Company	Trenz Electronic GmbH
PCN Number	PCN-20190103
Title	TE0630-01 to TE0630-02 Hardware Revision Change
Subject	Trenz Electronic TE0630 Hardware Change
Issue Date	20190315

This change affects all variations of TE0630 SoM of revision: TE0630-01

affected product	suggested upgrade
TE0630-01	TE0630-02

#11 Board revision coding updated to REV02

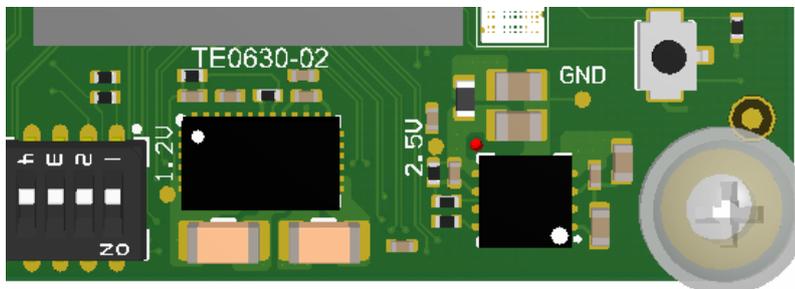
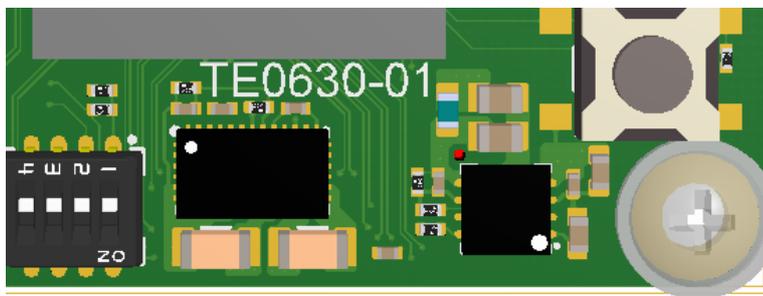
Type: Schematic Change

Reason: New revision

Impact: If hardware coding of board revision is used in design, update is needed.
